# **ADDENDUM NO. 1**

## **VILLAGE OF VERONA Main Street Reconstruction Phase II September 27, 2019**

Re: Village of Verona  
Main Street Reconstruction Phase II

### WATER MAIN BACKFILL DETAIL

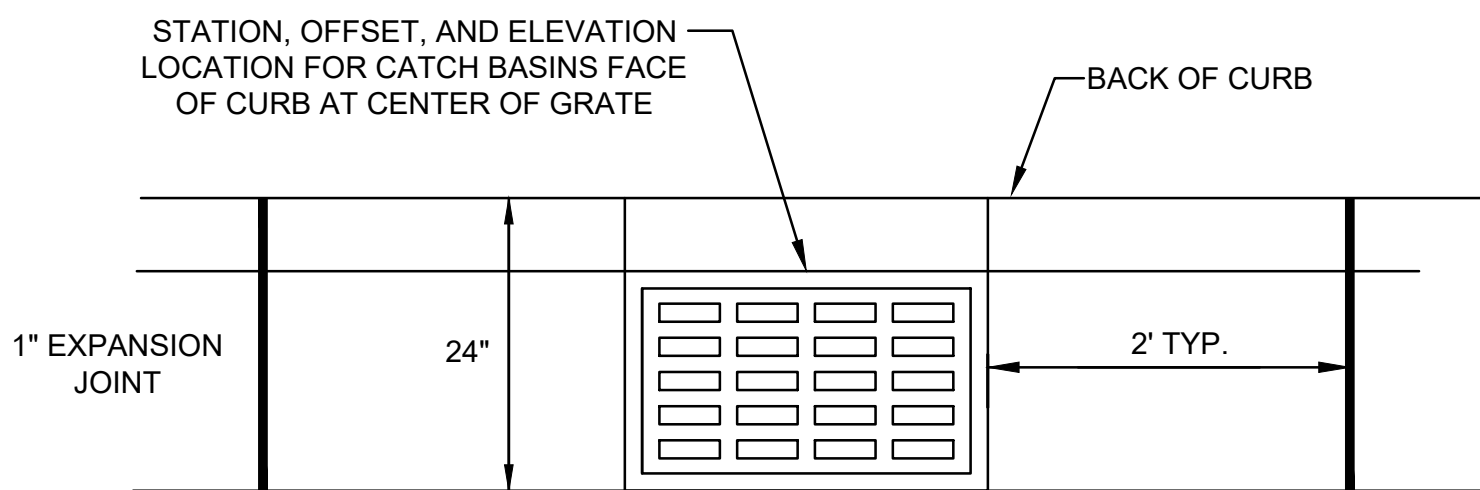
- a. The Water Main Backfill Detail has been revised to note the installation of tracer wire.
- b. Tracer Wire Detail has been added to this Sheet.

Please see the attached Sheet #3 with the changes indicated by revision clouds.

PLACE TRACER WIRE AS PER DETAIL.

NOTE: THE STRUCTURAL BEDDING IN THE PIPE ZONE SHALL MEET THE FOLLOWING REQUIREMENTS: WITHIN 2' OF ALL FITTINGS, VALVES, OR ANY OTHER MATERIALS SUBJECT TO CORROSION, BEDDING AND BACKFILL MATERIAL SHALL BE ODOT 703.11 TYPE 3 (#57 OR #67) NATURAL STONE BASE. NO LIMESTONE WILL BE PERMITTED IN THIS AREA. BEYOND THOSE LIMITS, LIMESTONE WILL BE PERMITTED IN THE PIPE ZONE SATISFYING THE SAME GRADATIONS.

GENERAL NOTES

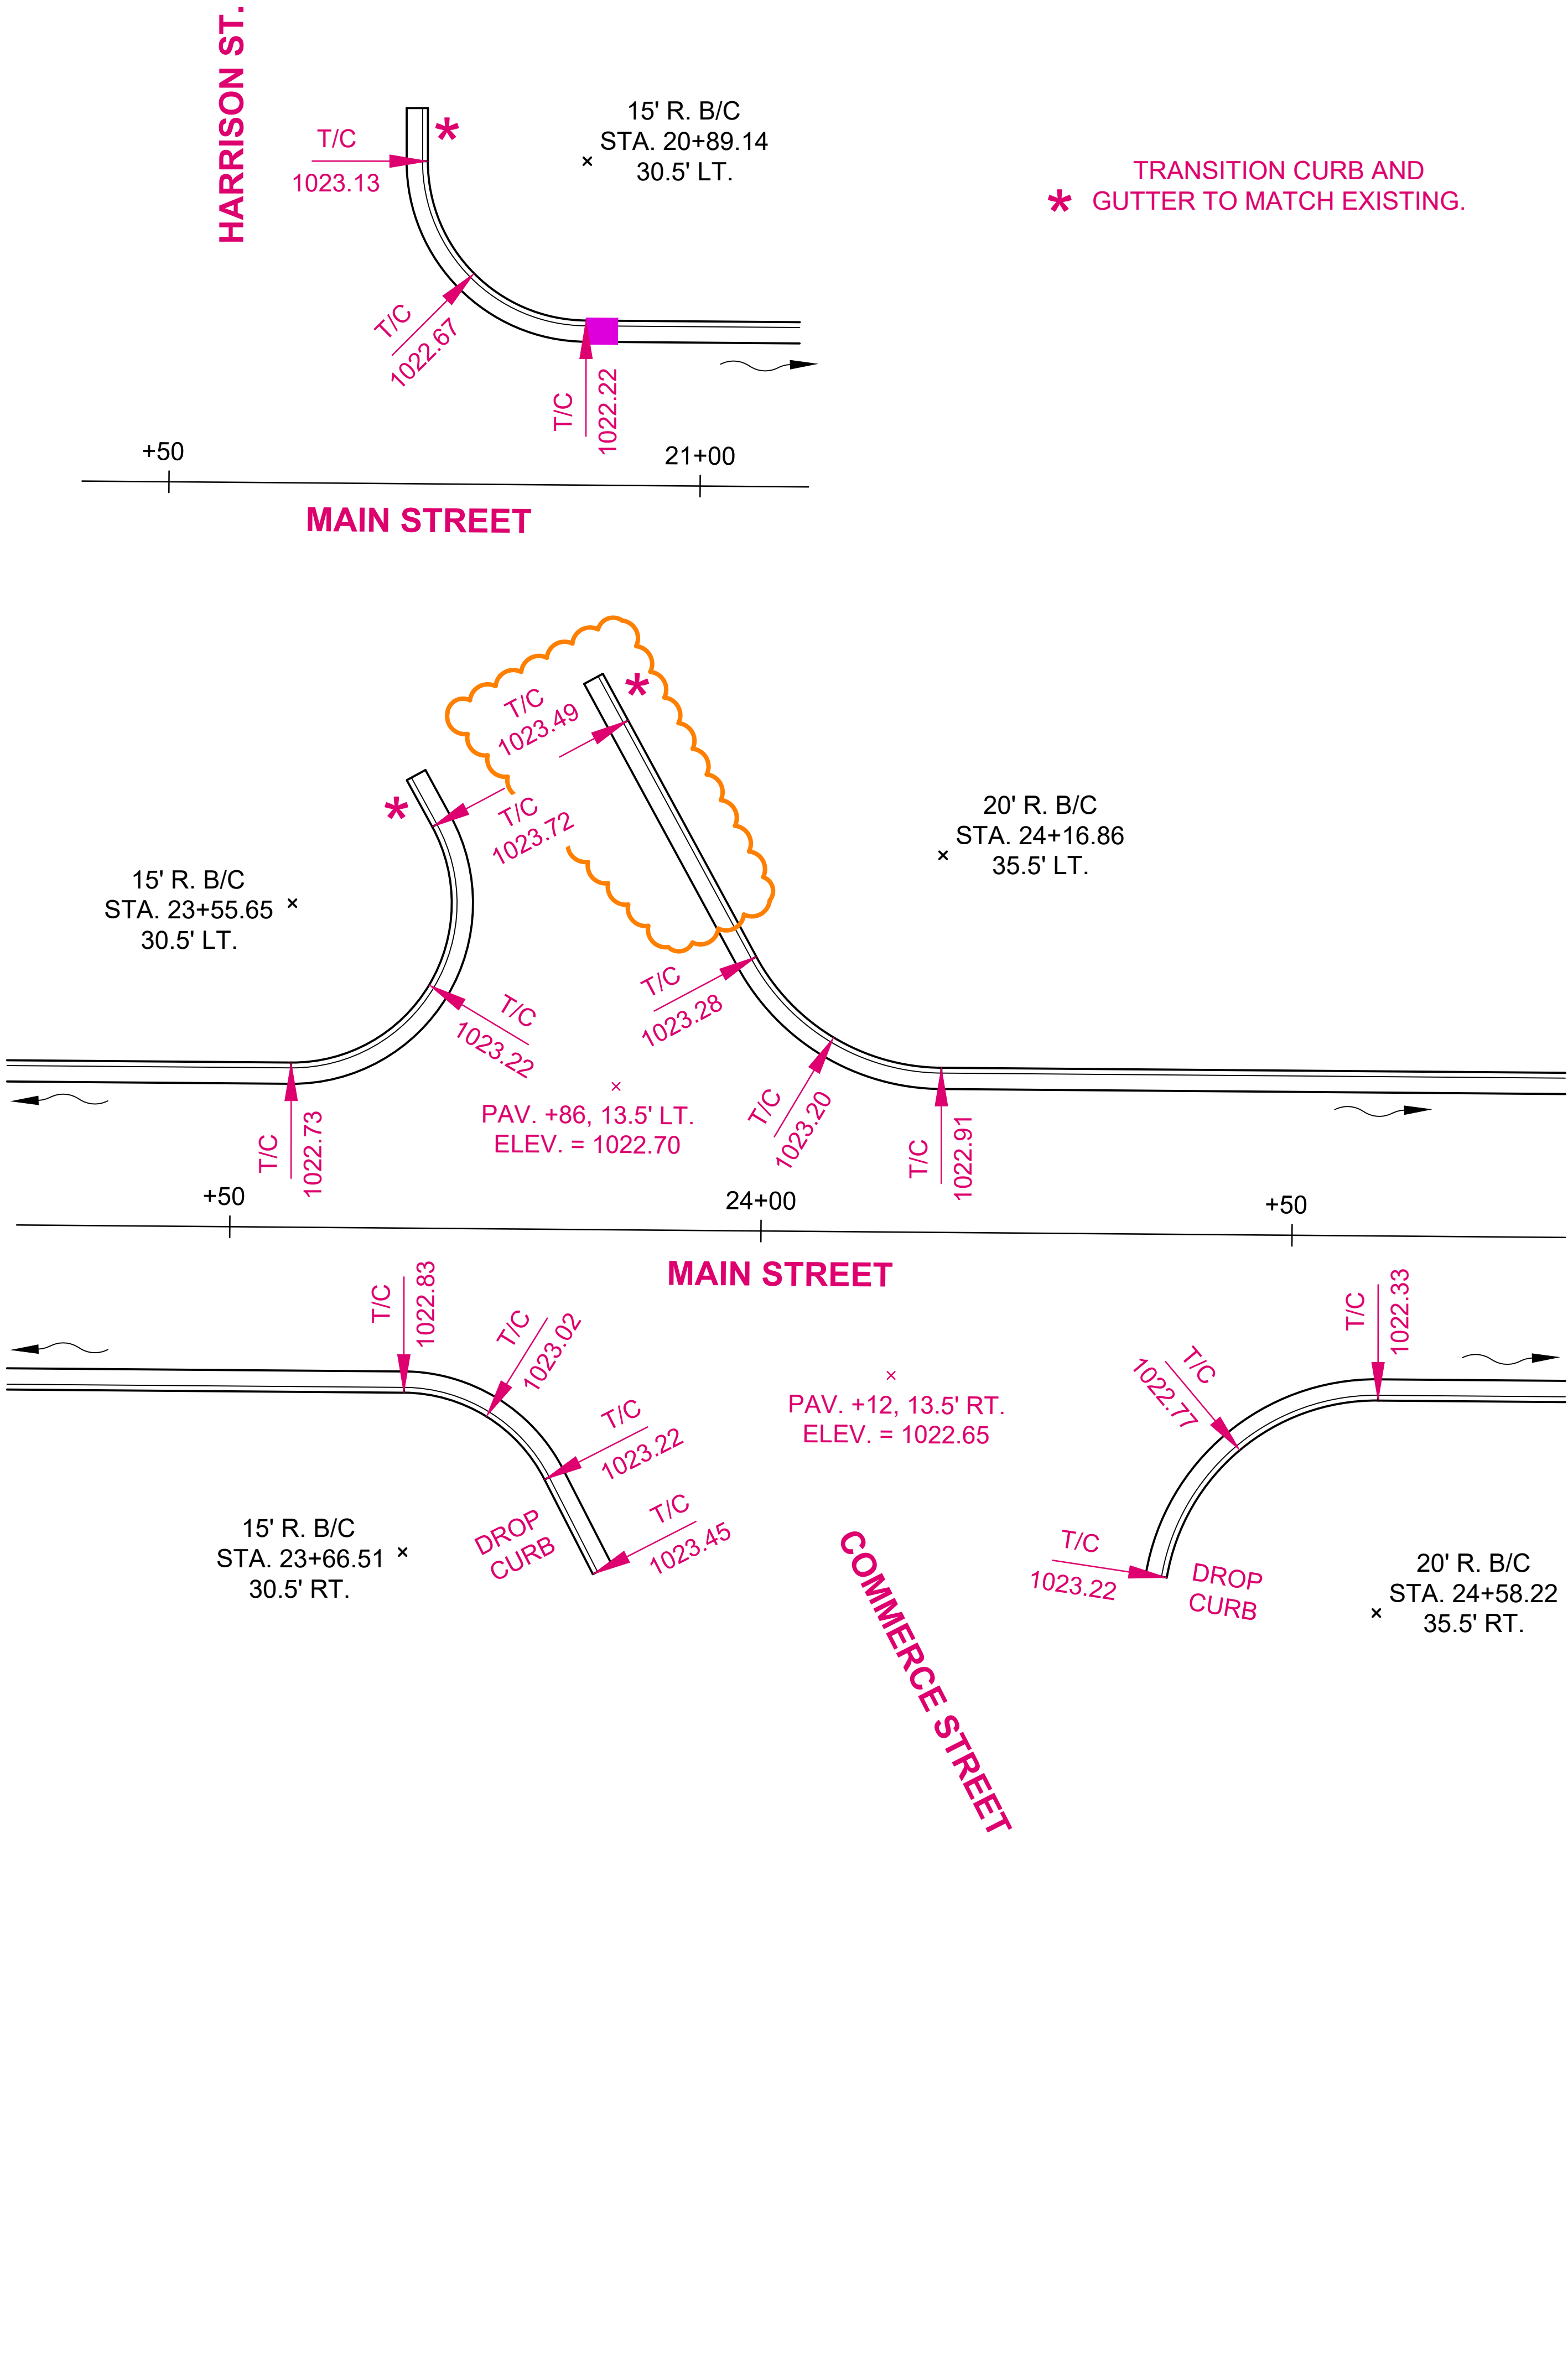
#### **3. Sheet #5 - General Notes**

- a. General Notes #14, #42, and #44 have been revised. Please see the attached sheet with the changes indicated by revision clouds.

GENERAL SUMMARY

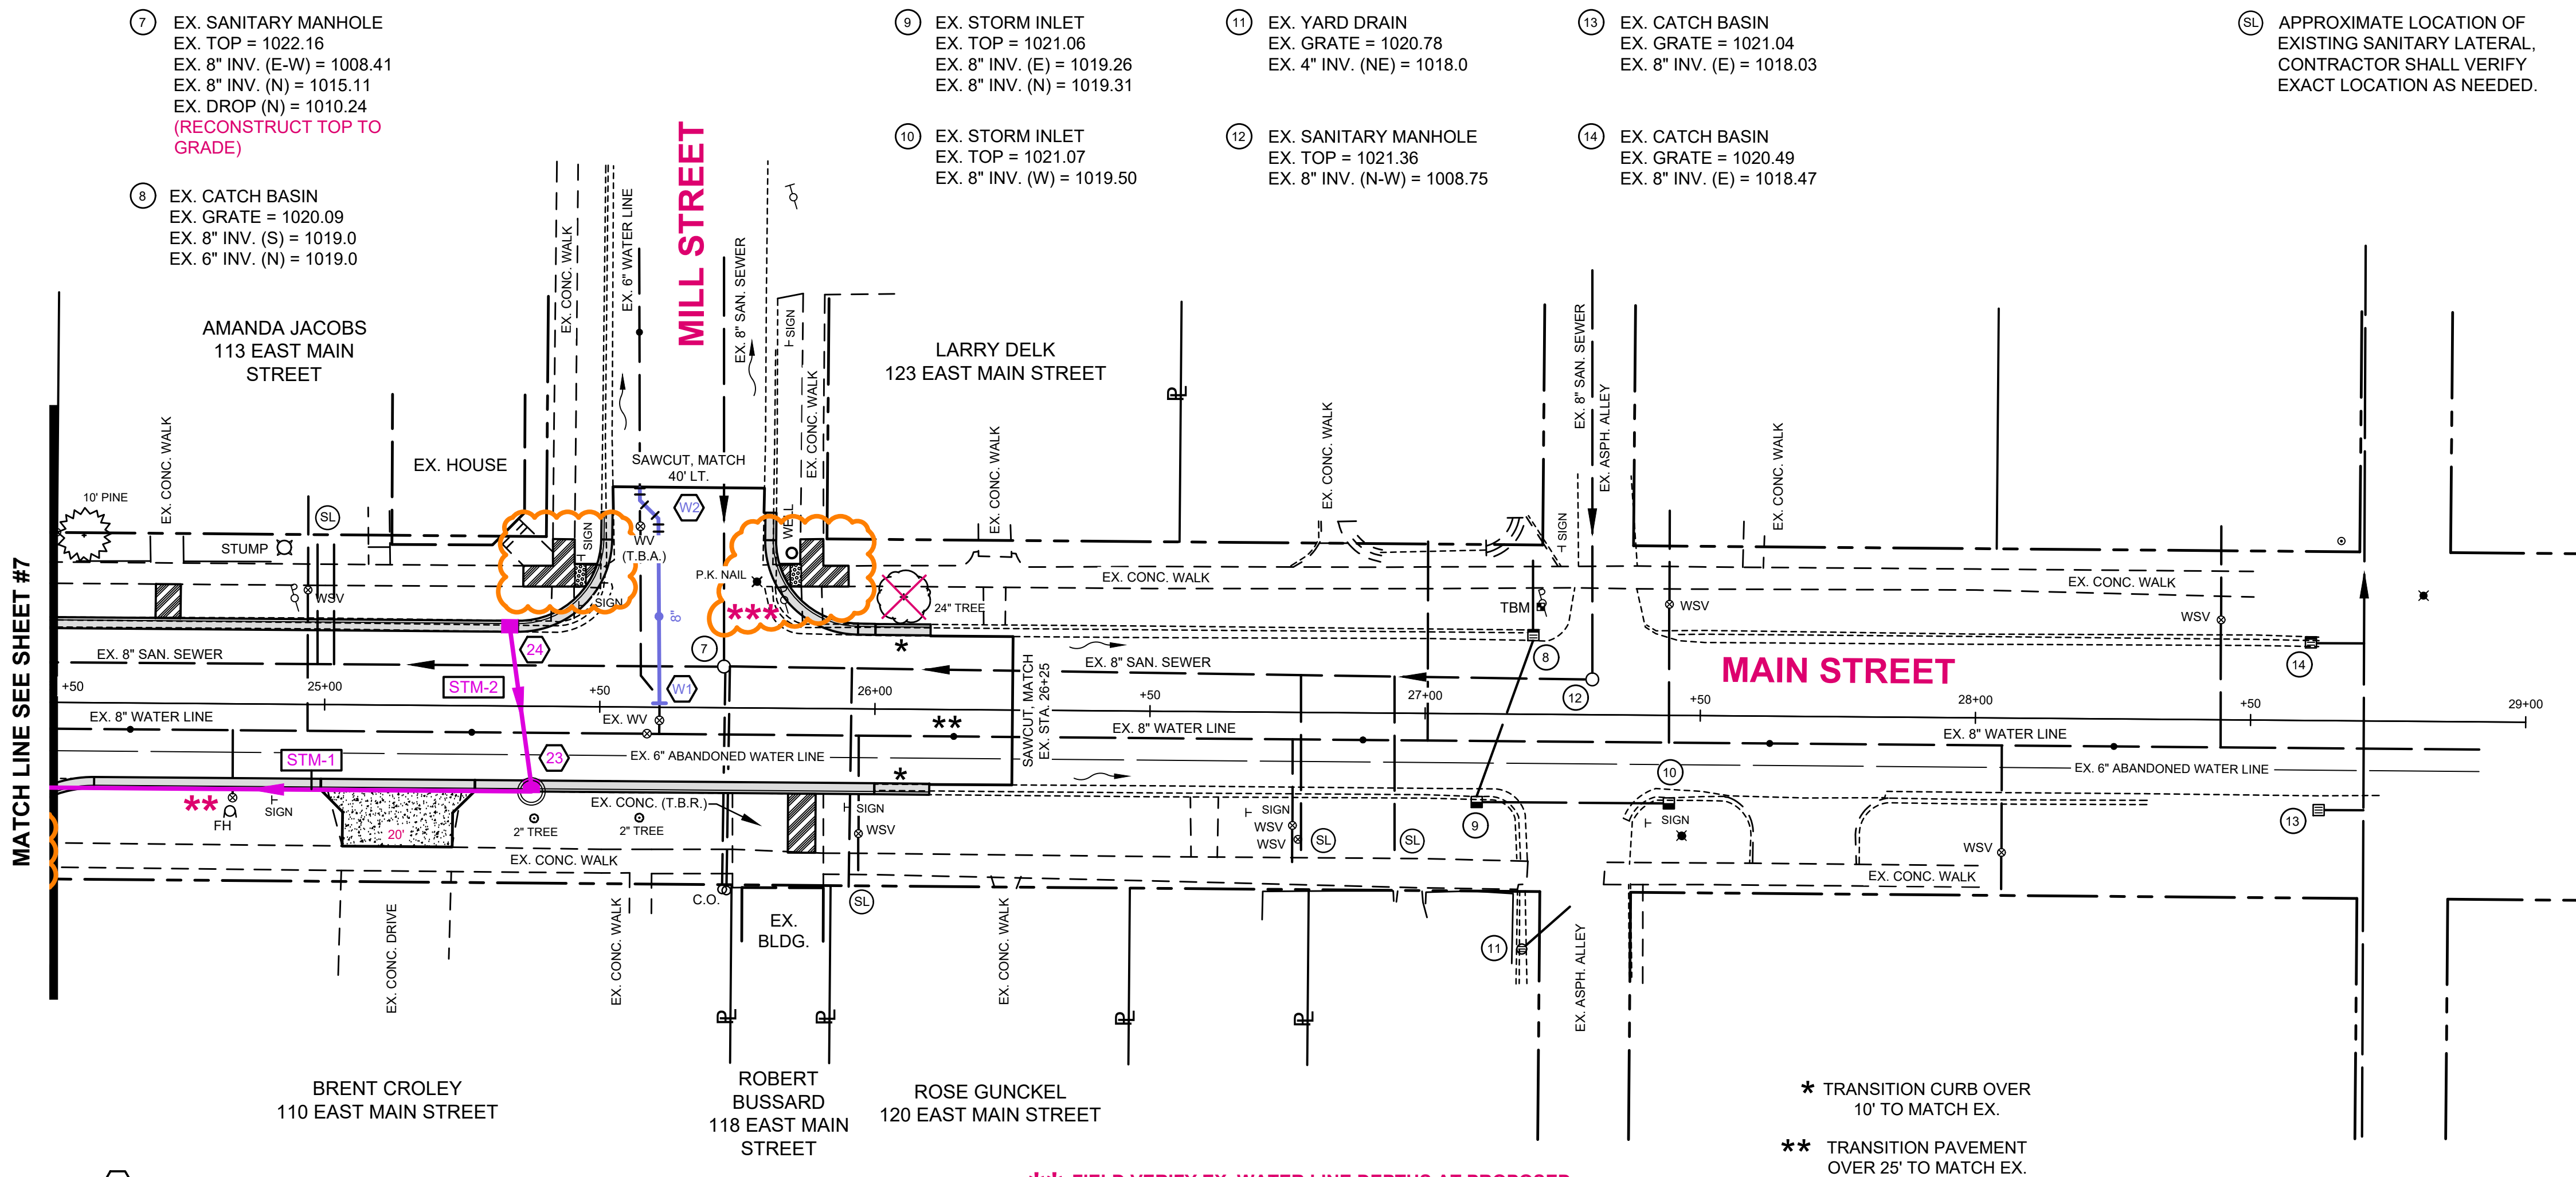
4. Sheet #6 - General Summary and Radius Details

- a. The Radius Detail at the NE corner of Main and Commerce Streets has been revised to show the installation of additional curb and gutter. Please see the attached sheet with the changes indicated by a revision cloud.

**PLAN AND PROFILE  
MAIN STREET RECONSTRUCTION - PHASE II  
THE VILLAGE OF VERONA**

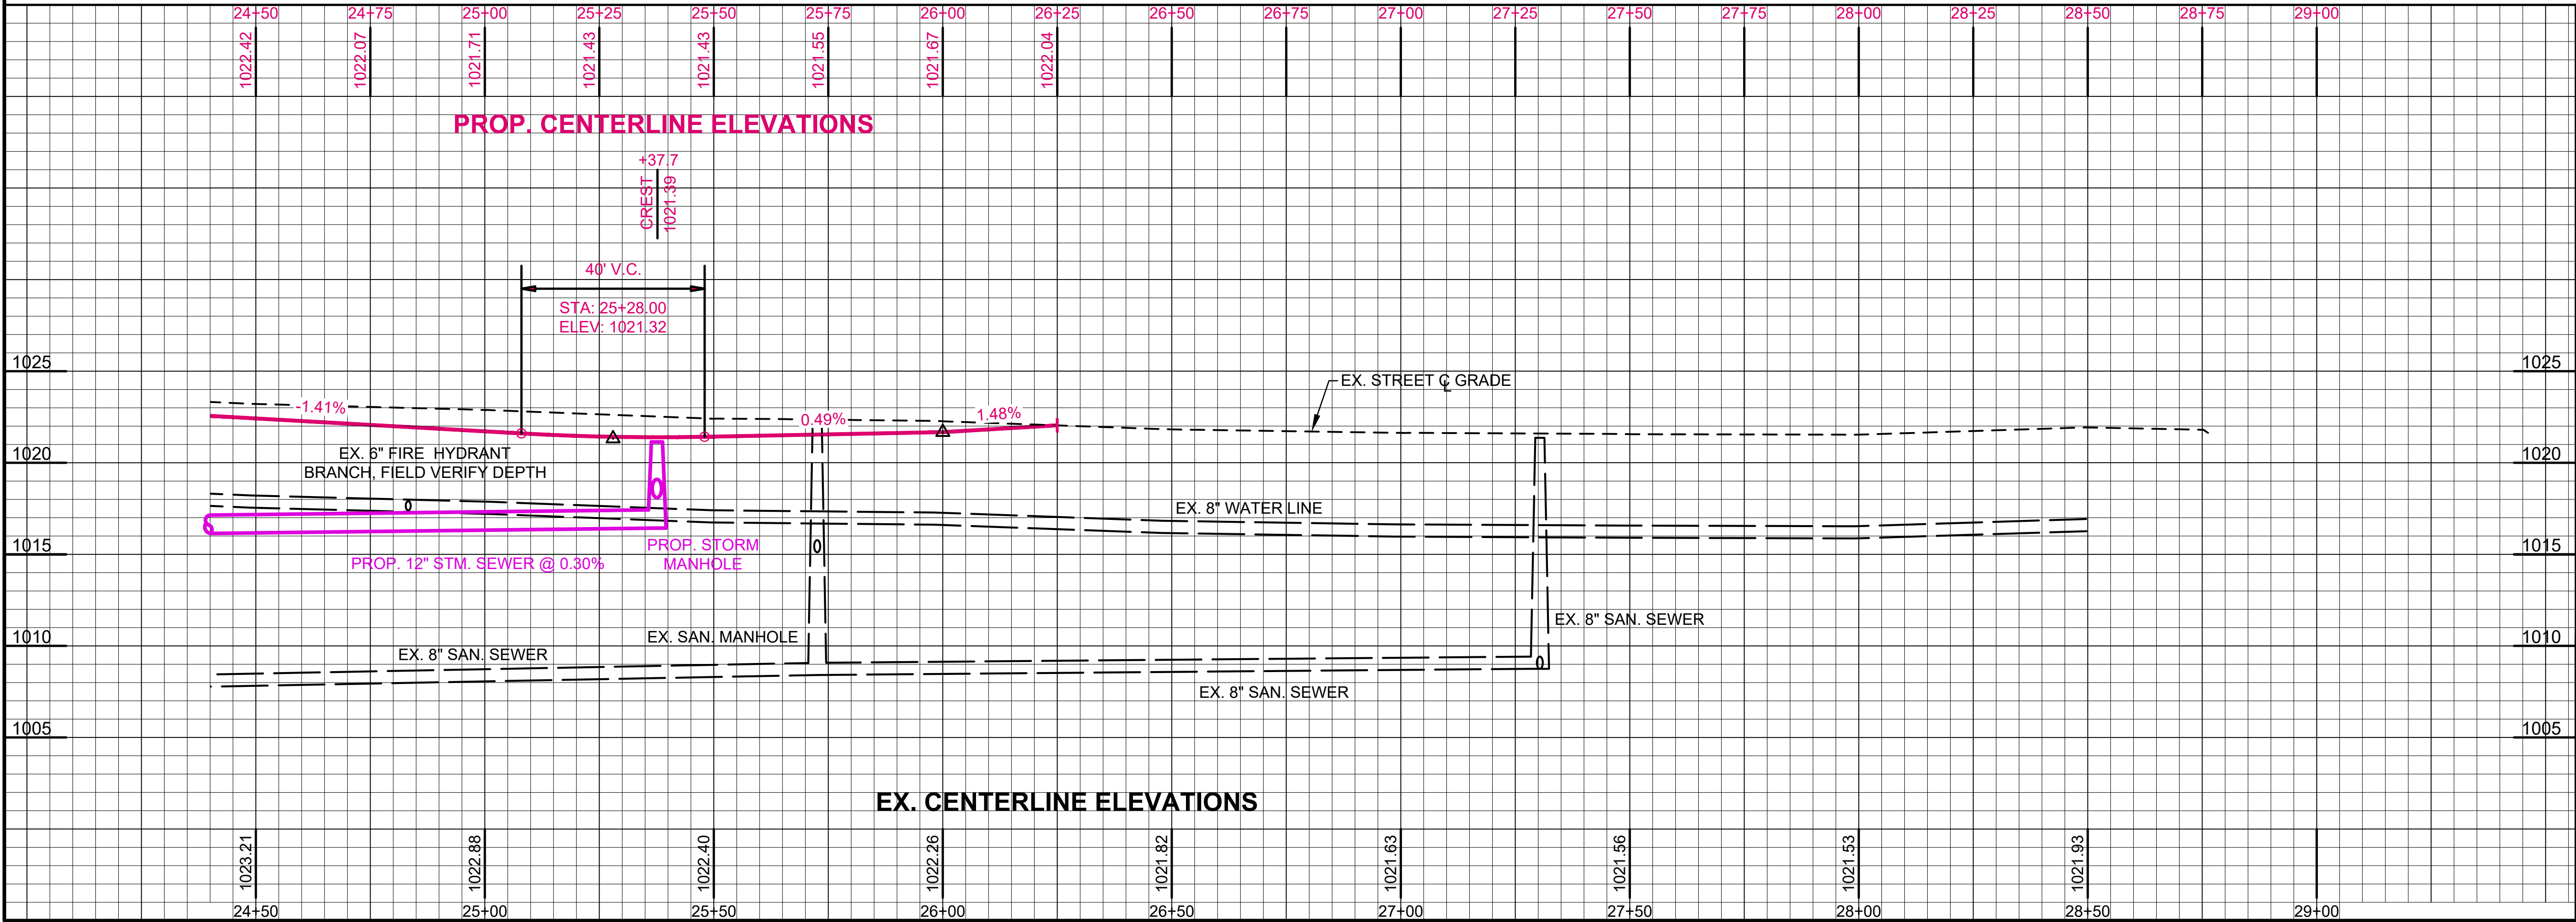
6. Sheet #8 - Plan and Profile

- a. The sidewalk at the NW and NE corners of Main and Mill Streets has been revised. Please see the attached sheet with the changes indicated by revision clouds.
